# S. FLATROCK TRAIL EXTENSION

## PRELIMINARY DRAINAGE PLAN

**1st Review**  
Contact Andrew Renner with any questions.  
ARenner@bhinc.com  
Re-submittal required. Please provide responses to the provided comments to expedite the next review.  
Please note: A comment labeled "TYP" indicates that the comment needs to be addressed on all sheets where a similar condition occurs.  
Due to lack of updated reference material and information provided, this preliminary drainage report could not be fully reviewed. Additional new comments may be included on the next submittal once all required information is included.

**CLIENT**  
MURPHY CREEK DEVELOPMENT, LLC  
S. FLATROCK TRAIL EXTENSION  
AURORA, COLORADO  
PRELIMINARY DRAINAGE PLAN  
HISTORIC DRAINAGE MAP

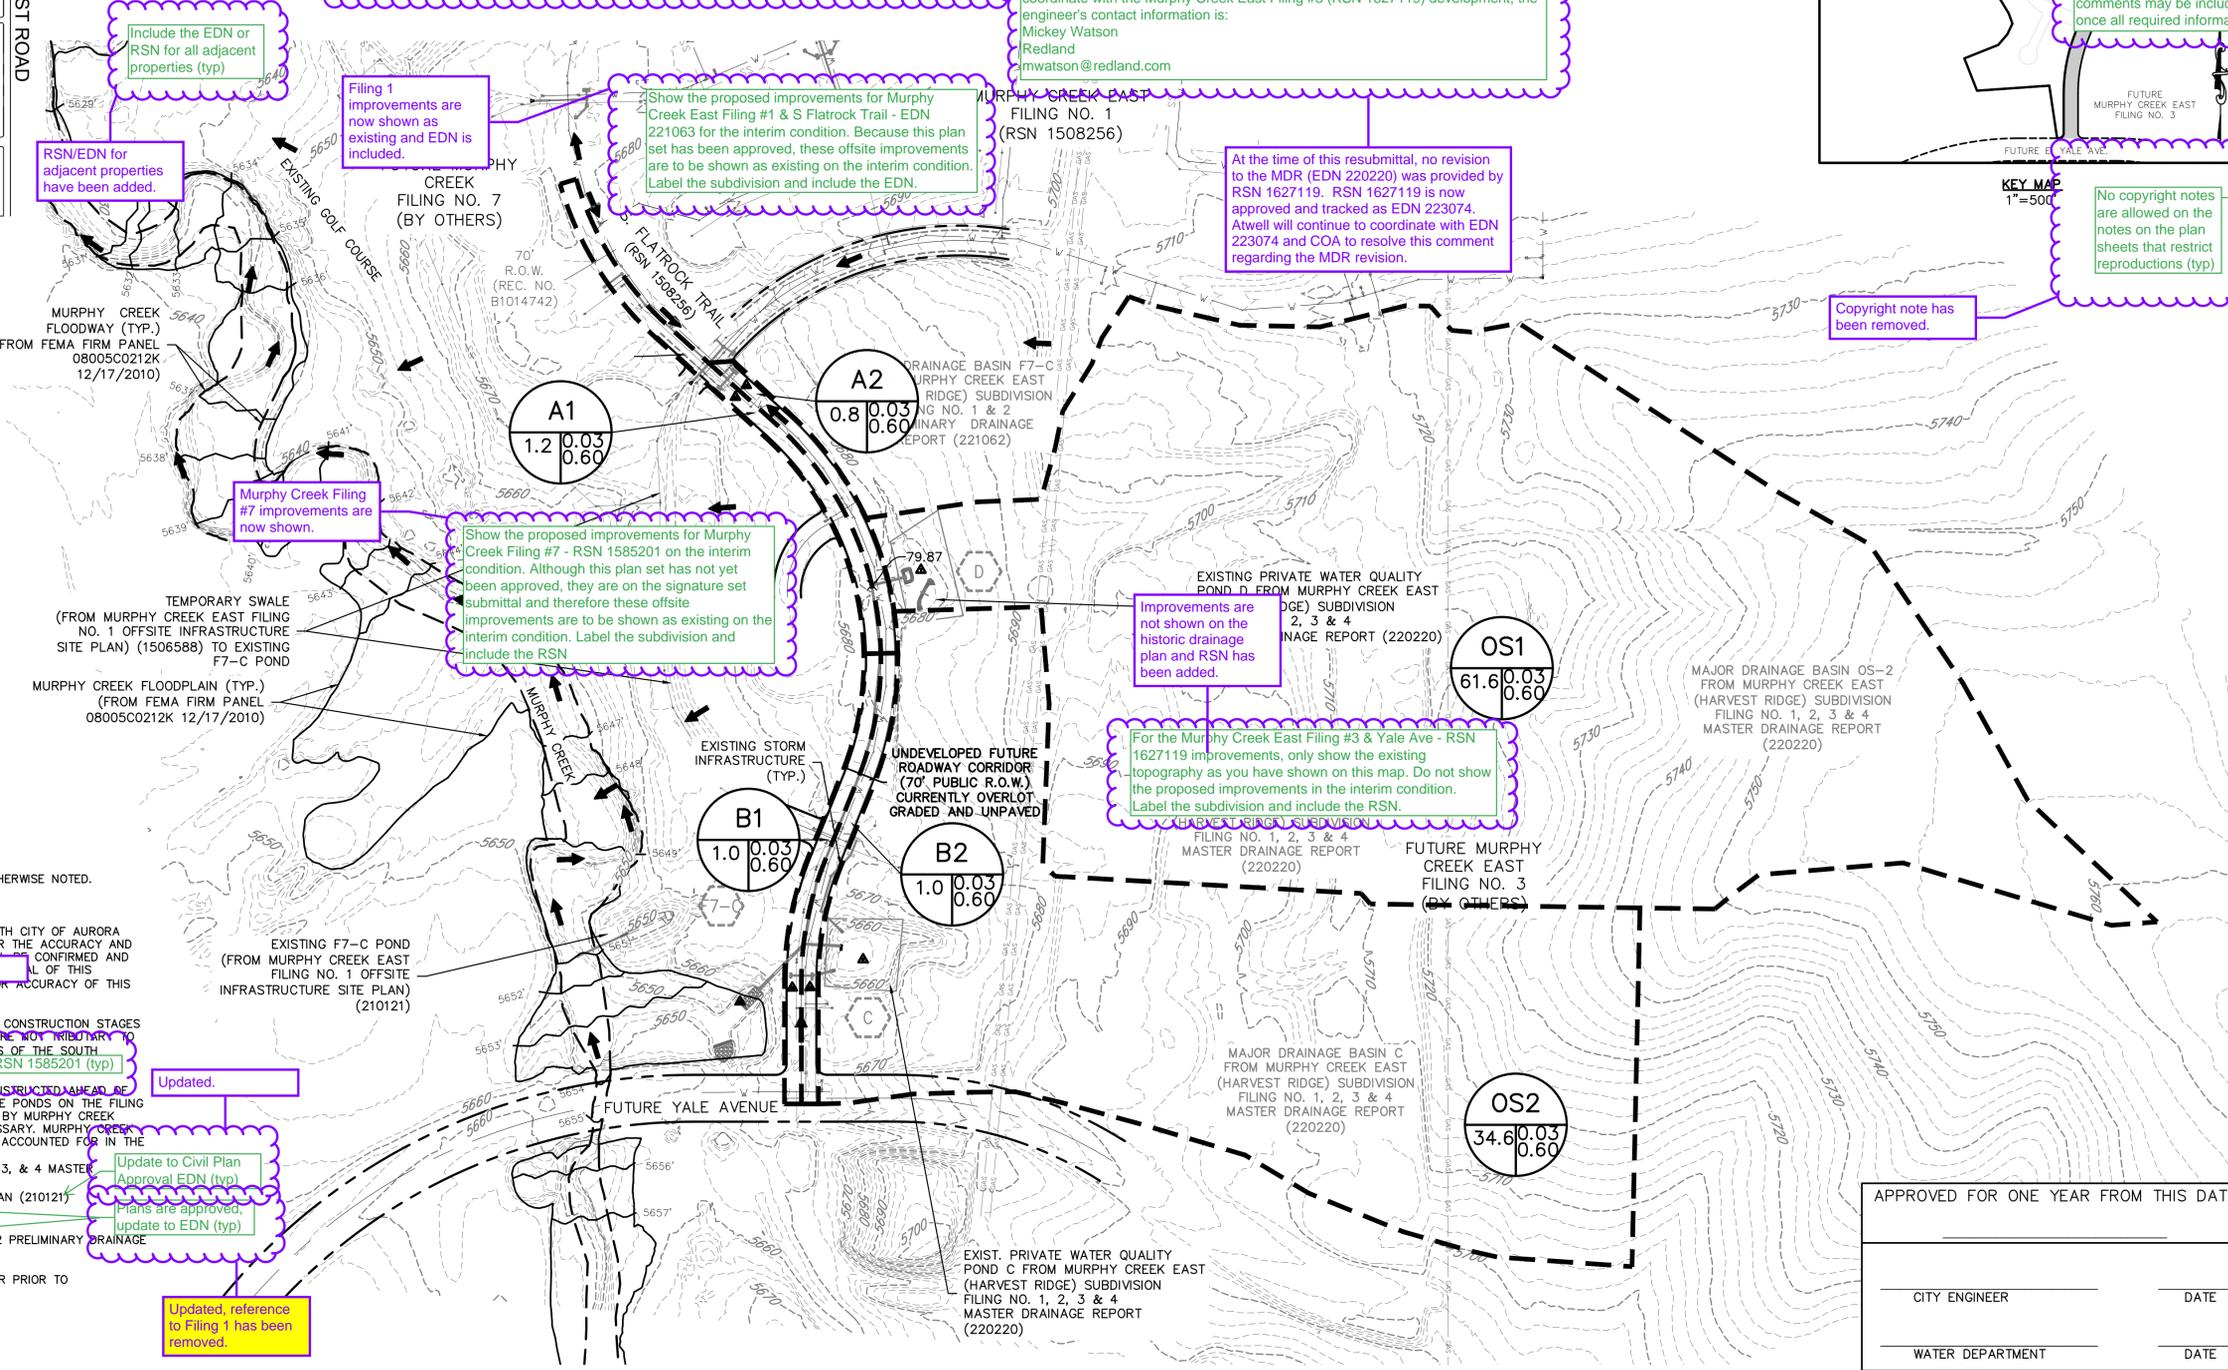
Analysis for this Preliminary Drainage Plan and Report need to be per two conditions, the interim condition and the ultimate condition. In the interim condition, show the proposed improvements for Murphy Creek East Filing #1 - EDN 221063 (which has been approved) as existing and Murphy Creek Filing #7 - RSN 1585201 (which is at signature set with minimal comments remaining) as existing, and for the Murphy Creek East Filing #1 - RSN 1627119 site show the existing topography as shown on this PDP. For the ultimate condition, show the proposed conditions for all 3 sites as existing with the proposed improvements for your design of S Flatrock Trail as proposed. If there is any confusion on this please reach out and we can discuss.

The layout you are showing from the MDR (EDN 220220) does not match the proposed improvements from the Murphy Creek East Filing #3 (RSN 1627119) PDP. Since the updated layout for RSN 1627119 is not consistent with the MDR (Pond D has been eliminated in RSN 1627119 and Pond C is being revised to treat tributary areas for both Pond C & D from the MDR), the MDR will need to be revised to reflect these changes. Since your site is directly affected by these MDR alterations as shown on RSN 1627119, do not resubmit this PD until the MDR revision has been submitted and has no significant comments remaining. Please coordinate with the Murphy Creek East Filing #3 (RSN 1627119) development, the engineer's contact information is:  
Mickey Watson  
Redland  
mwatson@redland.com

Include the EDN or RSN for all adjacent properties (typ)

Show the proposed improvements for Murphy Creek East Filing #1 & S Flatrock Trail - EDN 221063 for the interim condition. Because this plan set has been approved, these offsite improvements are to be shown as existing on the interim condition. Label the subdivision and include the EDN.

Show the proposed improvements for Murphy Creek Filing #7 - RSN 1585201 on the interim condition. Although this plan set has not yet been approved, they are on the signature set submittal and therefore these offsite improvements are to be shown as existing on the interim condition. Label the subdivision and include the RSN

For the Murphy Creek East Filing #3 & Yale Ave - RSN 1627119 improvements, only show the existing topography as you have shown on this map. Do not show the proposed improvements in the interim condition. Label the subdivision and include the RSN.

Update to Civil Plan Approval EDN (typ)

No copyright notes are allowed on the notes on the plan sheets that restrict reproductions (typ)

The analysis has been broken into two conditions as requested. The Historic Plan (interim) will show the proposed conditions of EDN 221603 and RSN 1585201 as existing, and the historic conditions of RSN 1627119. The Proposed Plan (ultimate) will then show the proposed conditions of RSN 1627119 as existing, and the improvements of this project as proposed.

RSN/EDN for adjacent properties have been added.

Filing 1 improvements are now shown as existing and EDN is included.

At the time of this resubmittal, no revision to the MDR (EDN 220220) was provided by RSN 1627119. RSN 1627119 is now approved and tracked as EDN 223074. Atwell will continue to coordinate with EDN 223074 and COA to resolve this comment regarding the MDR revision.

Improvements are not shown on the historic drainage plan and RSN has been added.

Murphy Creek Filing #7 improvements are now shown.

Plans are approved, update to EDN (typ)

Copyright note has been removed.

MURPHY CREEK DEVELOPMENT, LLC  
S. FLATROCK TRAIL EXTENSION  
AURORA, COLORADO  
PRELIMINARY DRAINAGE PLAN  
PROPOSED DRAINAGE MAP

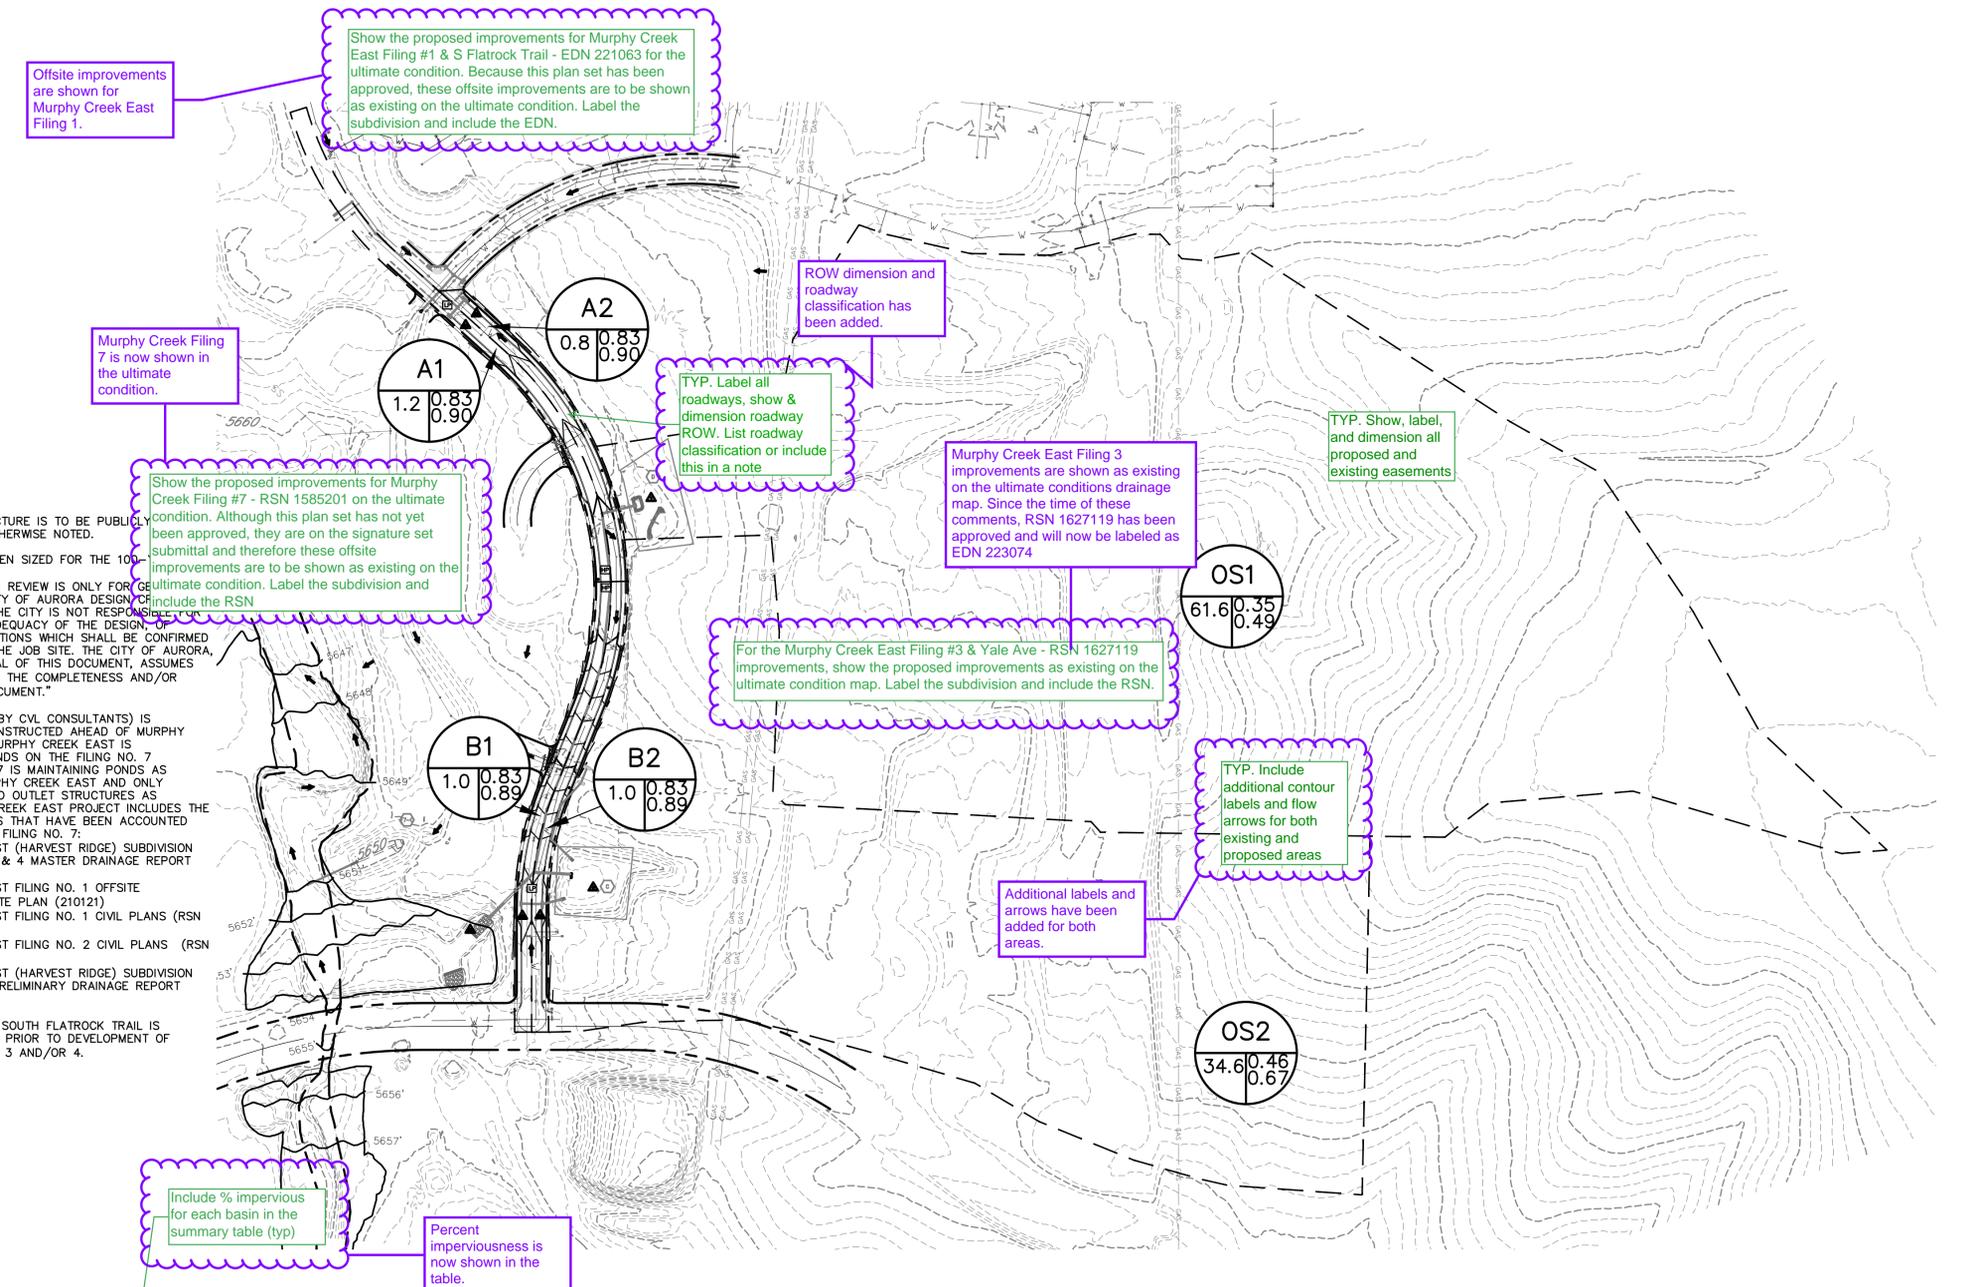
Show the proposed improvements for Murphy Creek East Filing #1 & S Flatrock Trail - EDN 221063 for the ultimate condition. Because this plan set has been approved, these offsite improvements are to be shown as existing on the ultimate condition. Label the subdivision and include the EDN.

Show the proposed improvements for Murphy Creek Filing #7 - RSN 1585201 on the ultimate condition. Although this plan set has not yet been approved, they are on the signature set submittal and therefore these offsite improvements are to be shown as existing on the ultimate condition. Label the subdivision and include the RSN.

TYP. Label all roadways, show & dimension roadway ROW. List roadway classification or include this in a note.

TYP. Show, label, and dimension all proposed and existing easements.

For the Murphy Creek East Filing #3 & Yale Ave - RSN 1627119 improvements, show the proposed improvements as existing on the ultimate condition map. Label the subdivision and include the RSN.

TYP. Include additional contour labels and flow arrows for both existing and proposed areas.

Include % impervious for each basin in the summary table (typ)

Offsite improvements are shown for Murphy Creek East Filing 1.

Murphy Creek Filing 7 is now shown in the ultimate condition.

ROW dimension and roadway classification has been added.

Murphy Creek East Filing 3 improvements are shown as existing on the ultimate conditions drainage map. Since the time of these comments, RSN 1627119 has been approved and will now be labeled as EDN 223074.

Additional labels and arrows have been added for both areas.

Percent imperviousness is now shown in the table.

DR. EAP CH. RDL  
P.M. RDL  
JOB # 21003852  
SHEET NO. 4

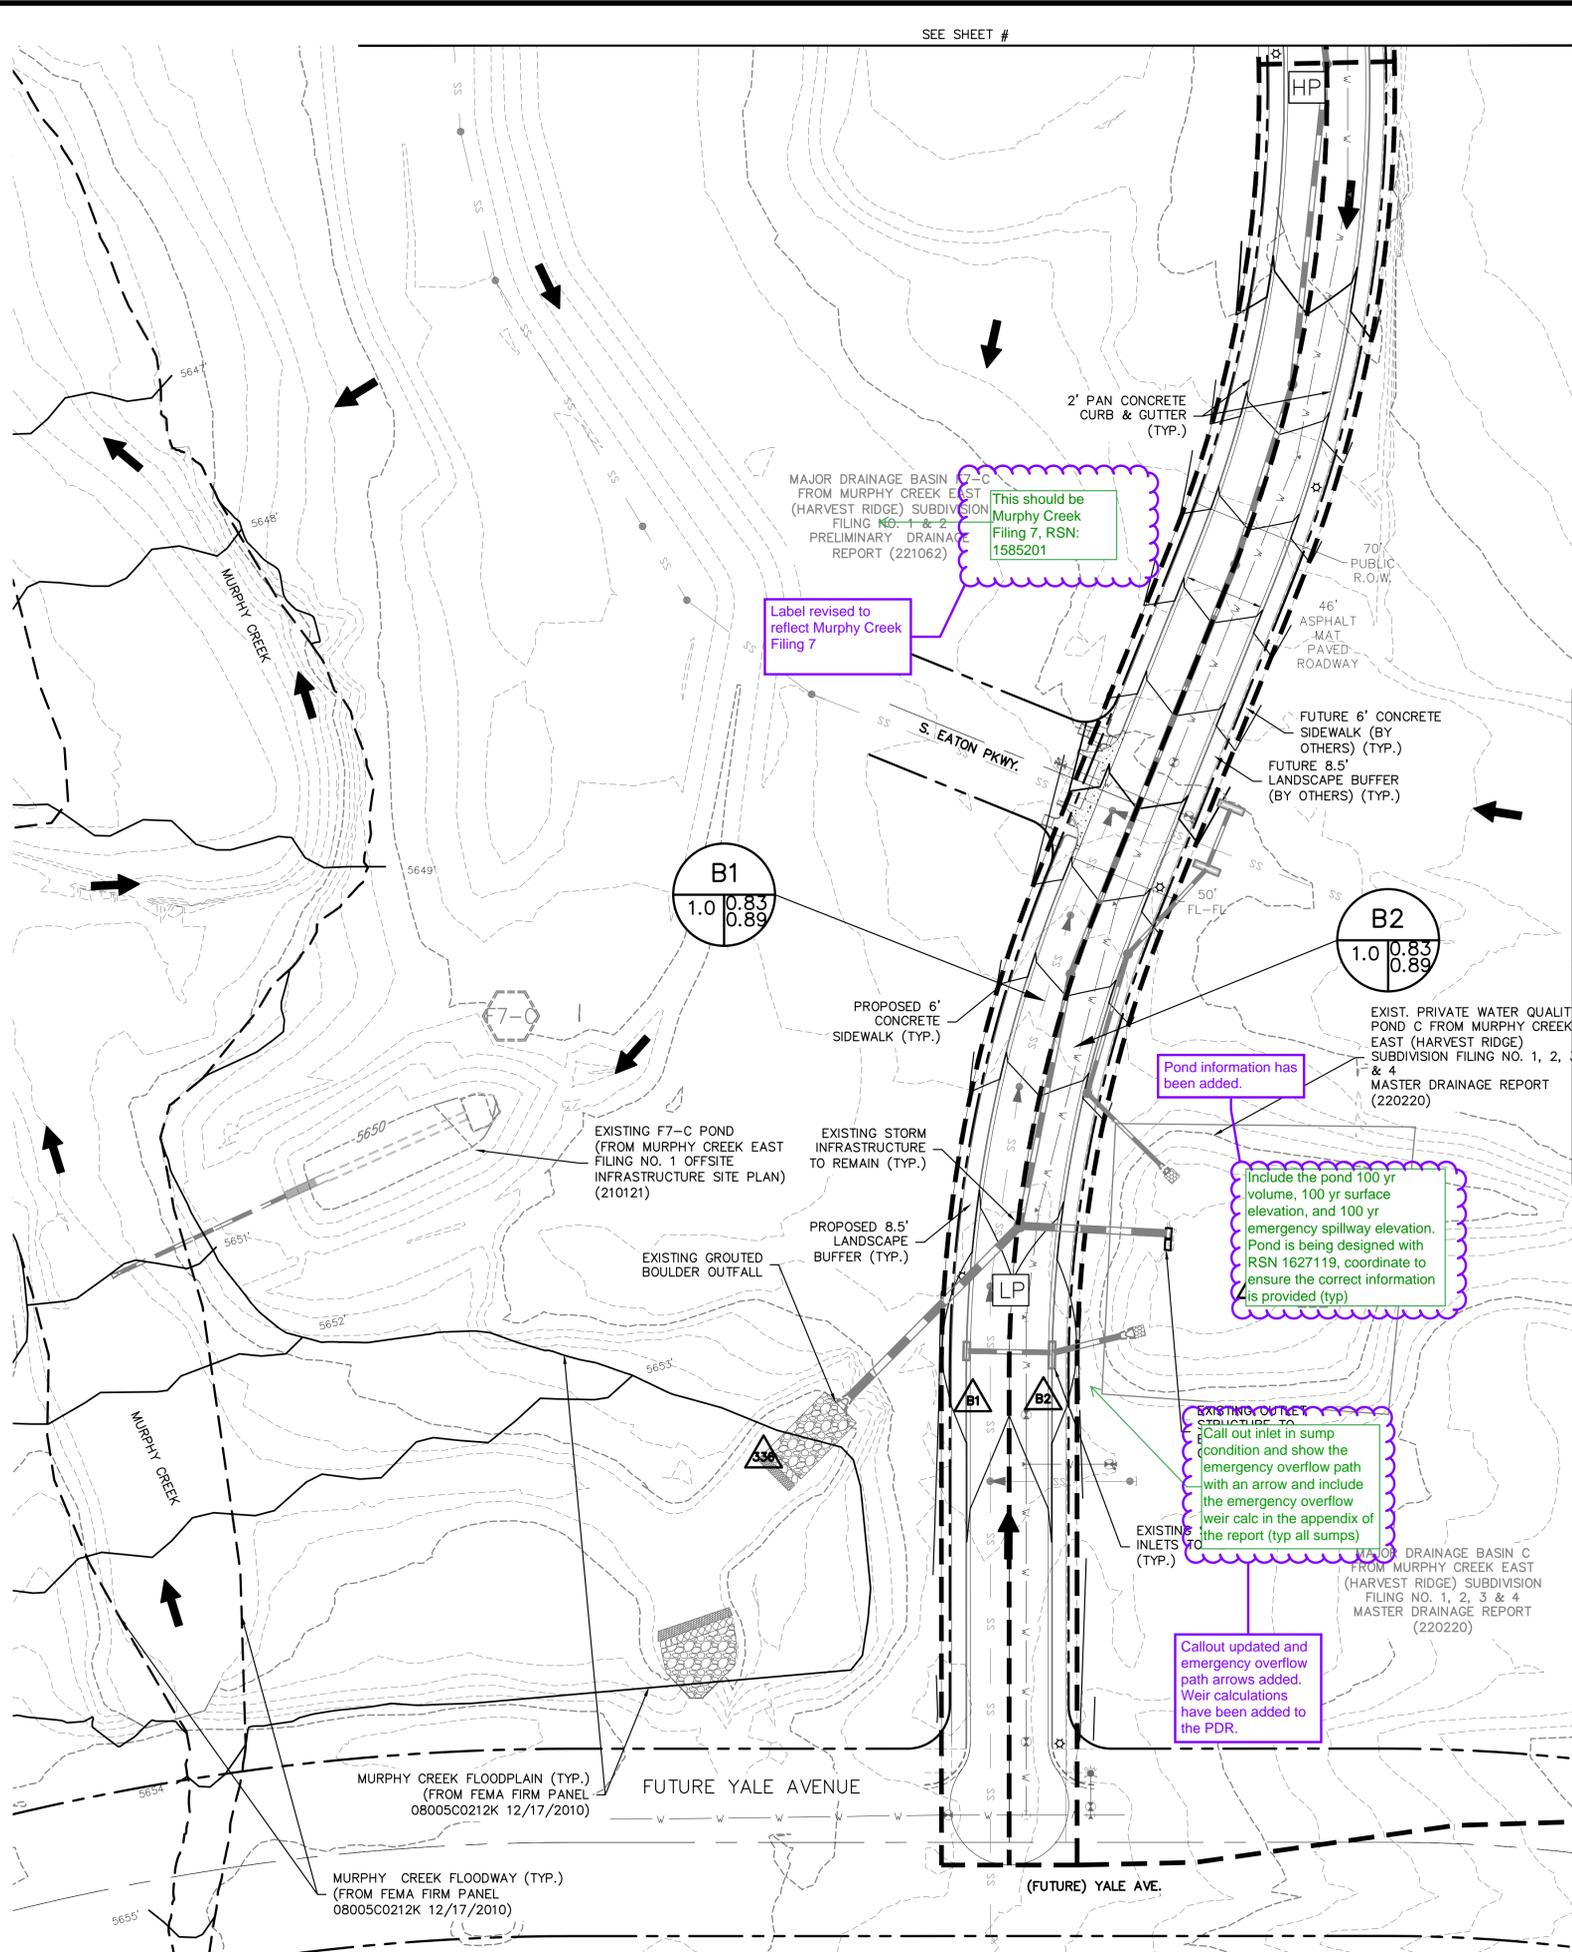
This should be Murphy Creek Filing 7, RSN: 1585201

Include the pond 100 yr volume, 100 yr surface elevation, and 100 yr emergency spillway elevation. Pond is being designed with RSN 1627119, coordinate to ensure the correct information is provided (typ)

EXISTING OUTLET STRUCTURE TO CALL OUT INLET IN SUMP (condition and show the emergency overflow path with an arrow and include the emergency overflow weir calc in the appendix of the report (typ all sumps))

Label revised to reflect Murphy Creek Filing 7

Pond information has been added.

Callout updated and emergency overflow path arrows added. Weir calculations have been added to the PDR.
